Hermes Property Unit Trust

Reading Metropolitan

Natural Environment Officer and Leisure & Recreational Comments

NEO and LR Comments Addendum

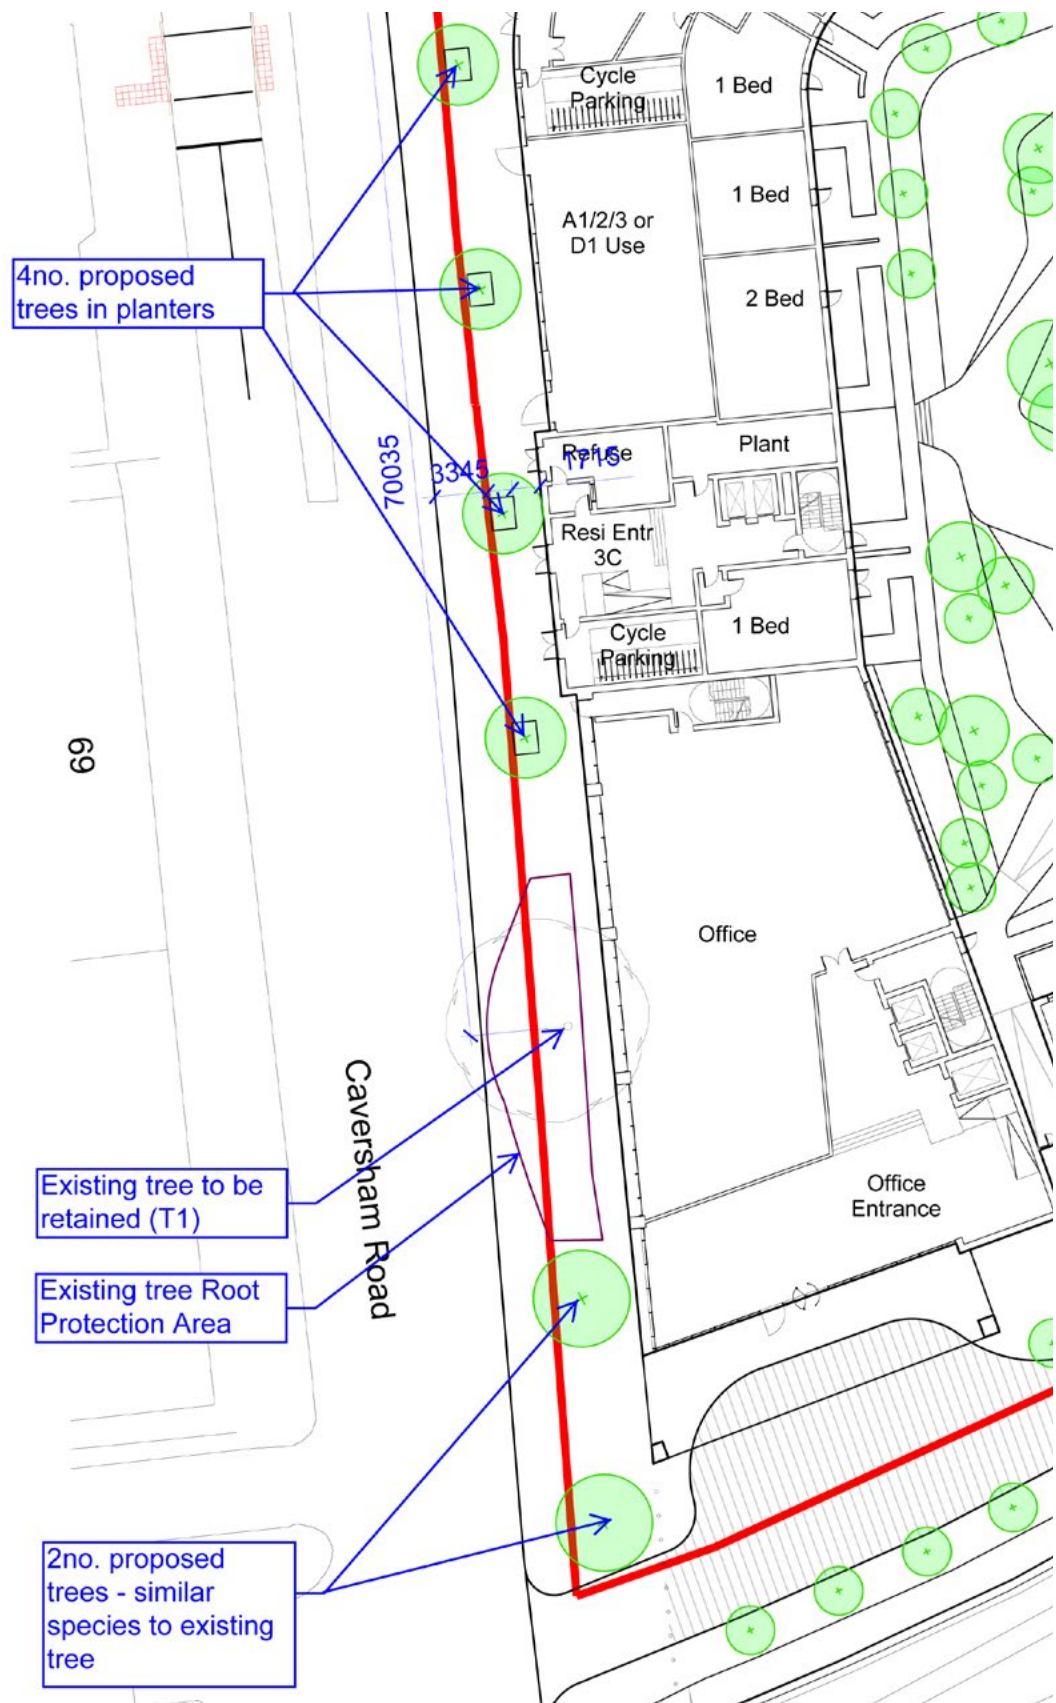
“It would appear from the information submitted that none of these [existing trees along Caversham Road frontage] would be retained. Whilst the applicant may argue mitigation planting could be provided, new trees will take many years to provide the multiple benefits of the existing, mature trees.”

The existing, mature tree (T1) is in good condition and will now be retained. In addition, a similar species to tie in with this existing tree for the 2no. proposed trees at the southern end of Caversham Road has now been included. With regards to the 4no. proposed trees in planters located above the culvert; these will be a smaller ornamental street tree that will complement the other species on this street. These new trees will be semi-mature.

A combination of existing, new and planter trees will form an attractive frontage, and the addition of another species will further increase the scheme’s biodiversity value.

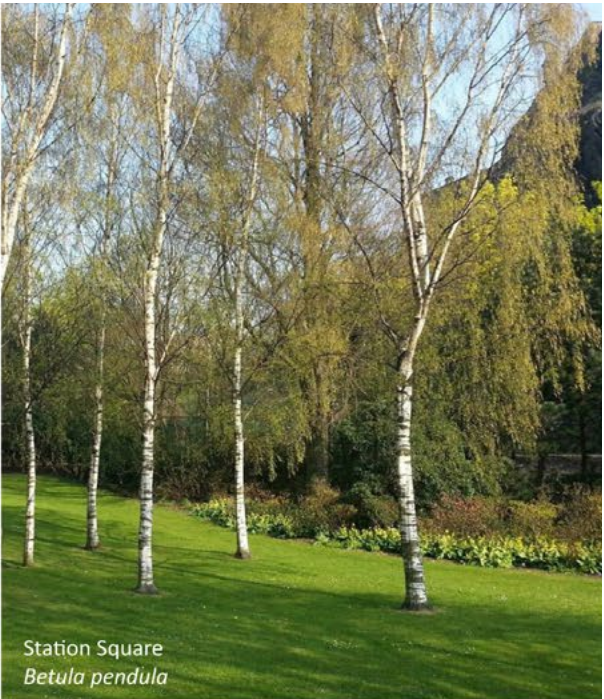
“..it would be suggested that a further species is introduced to either Middle Street or Railway Walk (currently both ornamental Pear) to add diversity, given the extensive use of *Pyrus* (ornamental Pear) in landscape schemes across the Borough.”

Two species are now proposed along Middle Street and Railway link:

- *Pyrus chanticleer* (Middle Street)
- *Prunus avium* (Railway Link)

1 Sketch Detail: Typical Tree Pit in Raised Planter
1:20 @ A3

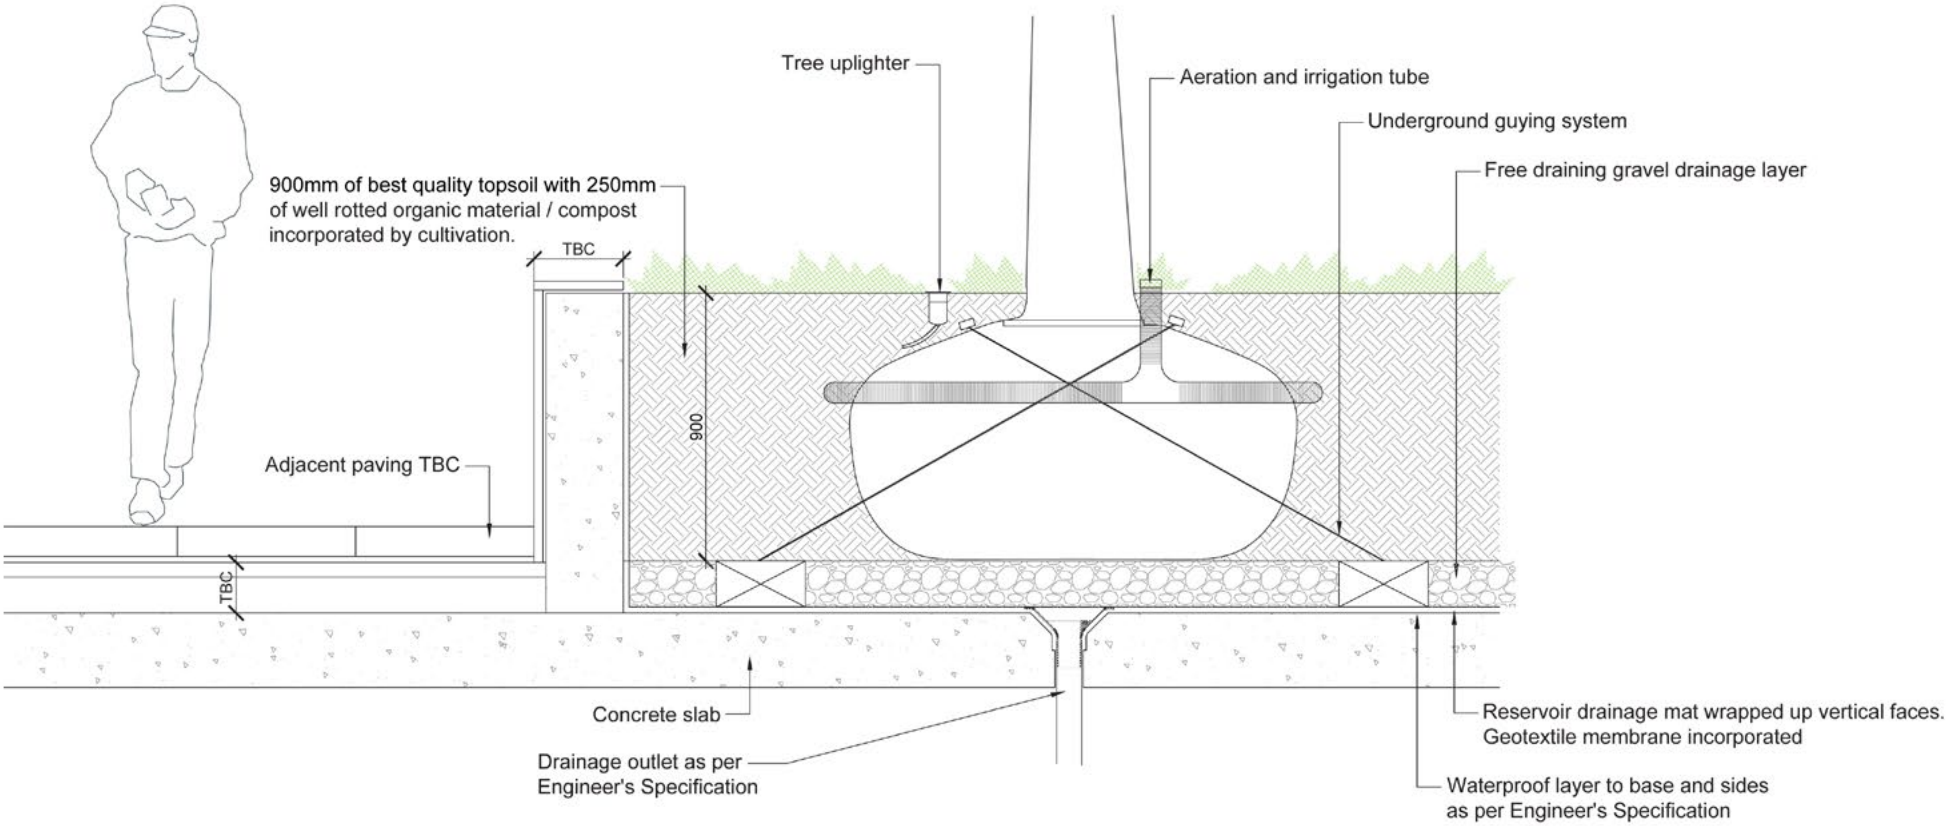
“It is noted that the development includes a basement level, which it is assumed works around the existing culvert indicated in 3.3 of the DAS? Hence confirmation of planting depths across the site will be required.”

The planting proposed over the basement carpark will have a minimum planting depth of 800mm and is of sufficient structure to properly support the proposals.

This has now been revised to 900mm. Details to be provided in addendum report.

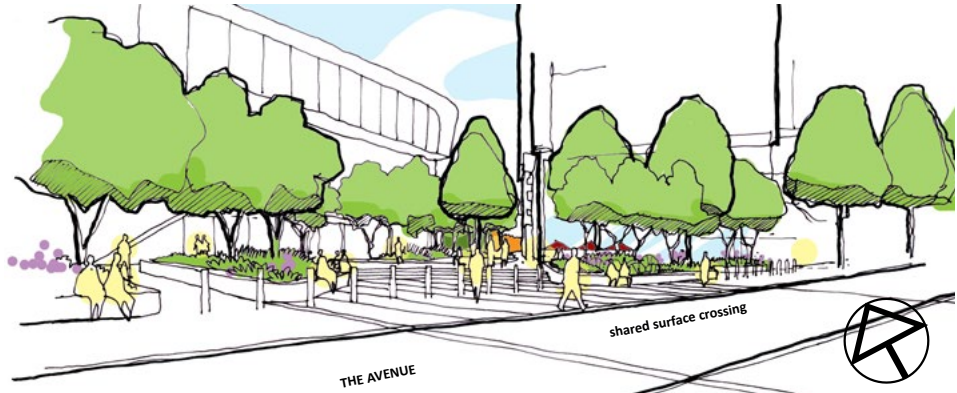
“The new Station Square has been described as representing a significant new public space for Reading and one of the key gateway spaces for the town. As such it lends itself to having a large scale feature providing a focal point and sense of place. Consideration should be given to a water feature, statue or other forms of public art, including provision for seating and large, town-scale trees for shading.”

Agreed. We have indicatively shown a large scale feature / focal point in Station Square on our illustrative landscape masterplan, along with seating edges along the raised planters and groups of large trees. Please refer to Figure 1.
